Overview: Production error; immobilizer wire (orange/black) in pin position #4 instead of pin position #5. Although an effort to correct the issue was made, some quantity of harnesses did get shipped before the issue was spotted. We are advising to inspect the harness BLADE connector before attempting to install the harness and program the module.

Overview: The FTI-STP1 harness may require modification for use in **automatic transmission (AT)** applications, some of the product was able to be modified before release, but a small quantity was released before being able to be modified internally.

FTI-STP1: Installation and Configuration Notes

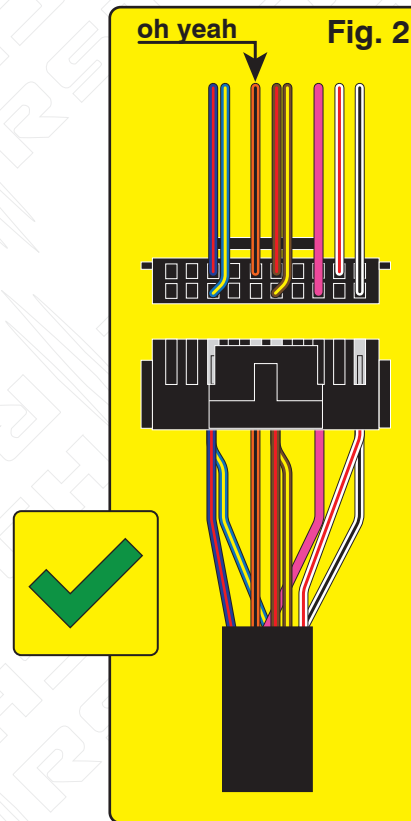
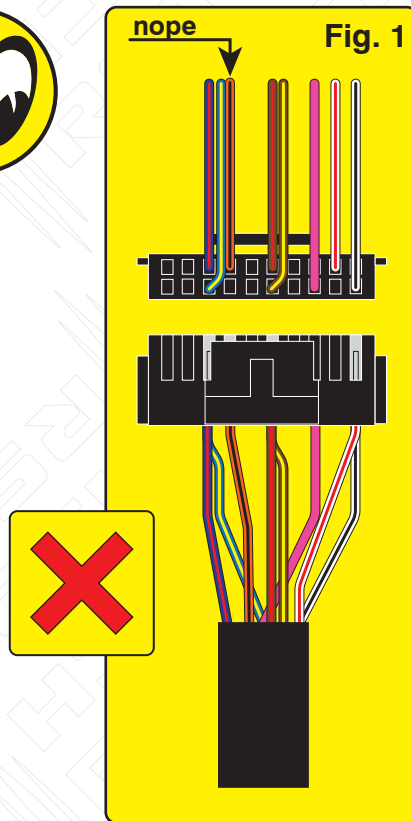
Issue: Module fails to program to vehicle, will not allow the vehicle to be remote started.

Correction: Step 1.) Locate the orange/black wire and confirm whether it is positioned as illustrated in Fig. 1 or Fig. 2. If the wire is as illustrated in Fig.1, proceed with Step 2 through 5 and complete the repair procedure outlined, if the wire is as illustrated in Fig. 2, correction is not necessary, proceed with harness installation and module programming.

Step 2.) Using a pick, lightly depress the catch that secures the terminal in the housing then remove the wire and terminal from the housing.

Step 3.) Using a fine tip razor or utility knife, insert the blade beneath the terminal catch and raise it slightly, so that it can be reused to secure the terminal when reinserted into the BLADE connector housing.

Step 4.) Refer to Fig. 2 for correct position of the orange/black wire (next to brown/red) then reinsert the terminal, pressing lightly until the catch 'snaps' into place, securing the terminal in the connector housing.

Step 5.) The repair is complete, proceed with installation and programming.

MODIFICATION REQUIRED FOR AUTOMATIC TRANSMISSION APPLICATIONS ONLY

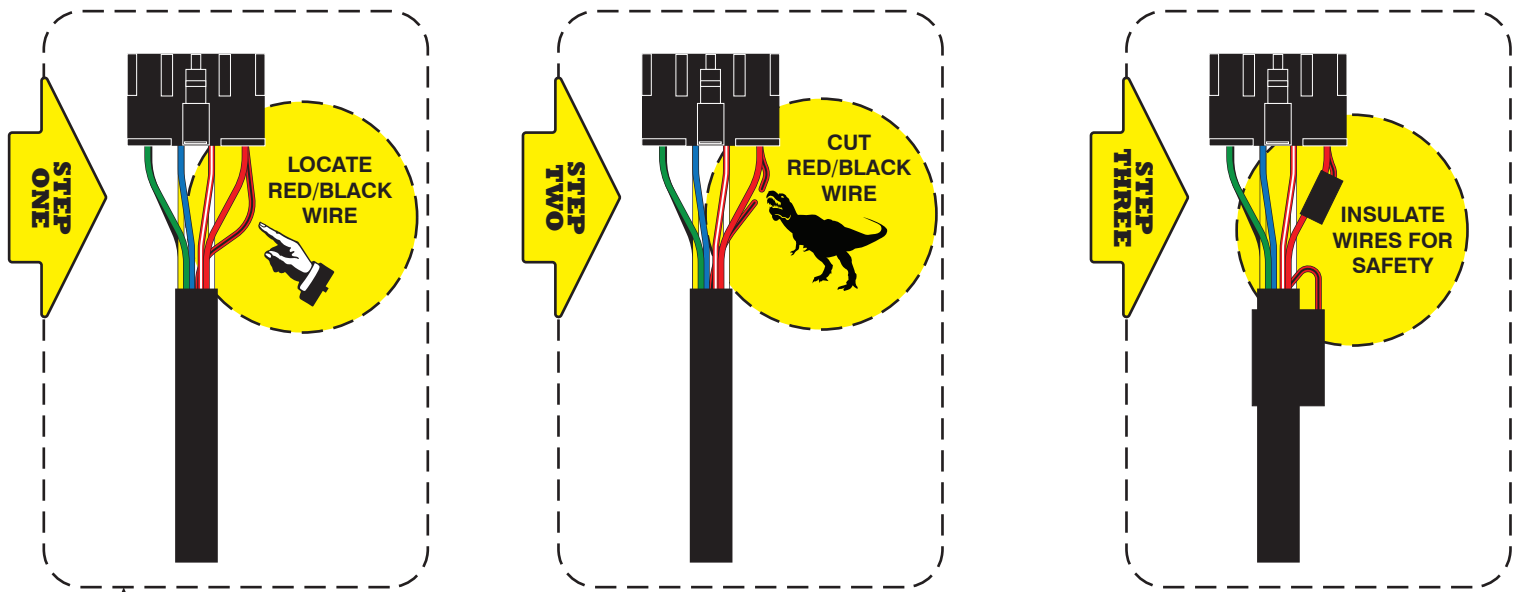
Issue: The FTI-STP1 T-harness has been designed to be compatible with AT (automatic transmission) & MT (manual transmission) applications, but due to a production oversight, the selection mechanism was defaulted to MT mode.

Using a harness configured for an MT application, in an AT equipped vehicle, could result in vehicle module damage, it is advised that the harness be returned to AT mode before installation in vehicles equipped with an automatic transmission.

Correction: Locate the **red/black (+ Clutch)** wire provided in the CN1 connector of the main harness assembly. Cut the **red/black** wire, either flush to the CN1 connector, or leaving enough wire exposed so that you can insulate and secure the ends of the wire that remain after cutting. Insulate each of the remaining ends of the **red/black** wire and secure to prevent any possibility of a short circuit.

If the red/black wire already been disconnected, no further modification is required for AT equipped vehicles.

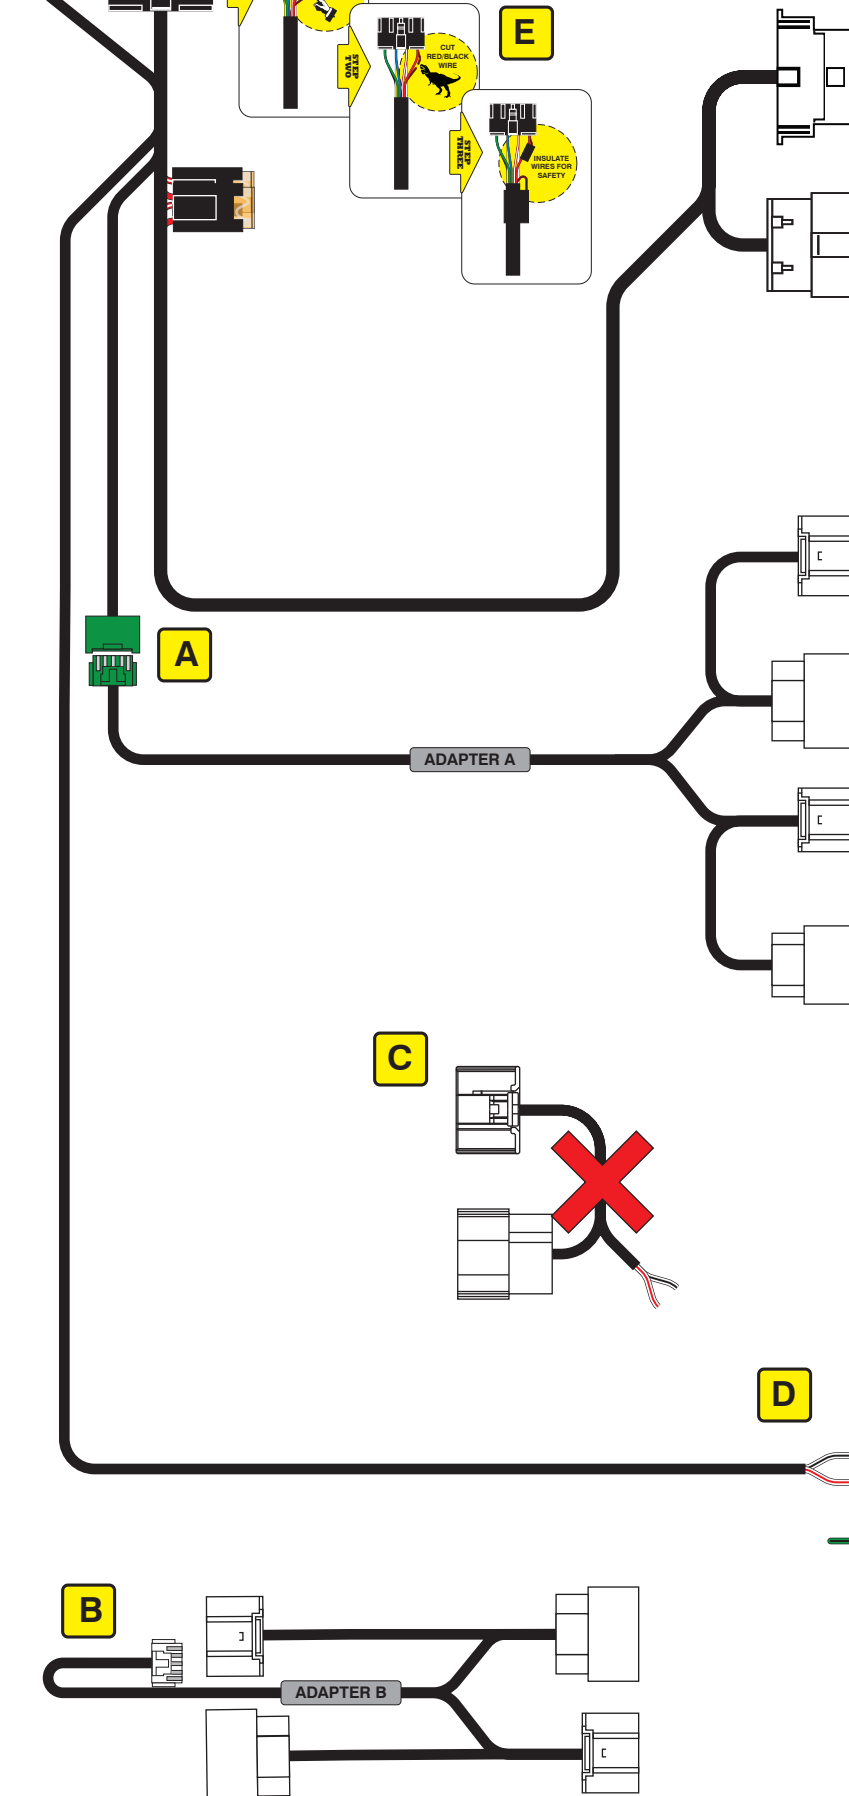
Type 3 Immobilizer: Immobilizer connection is located at the ECU, located on the passenger side of the engine compartment, and requires modification of the STP1 harness by removing the 35-pin T-section, as illustrated. The **white/red & white/black** wires can be extended to the ECU location, the **white/black** wire connecting to the connector side of the wire illustrated.

CMX, CM7, and CM9 Series controllers: No configuration changes required. See previous page for modification required at the CN1 connector parking light (+ clutch) output position.
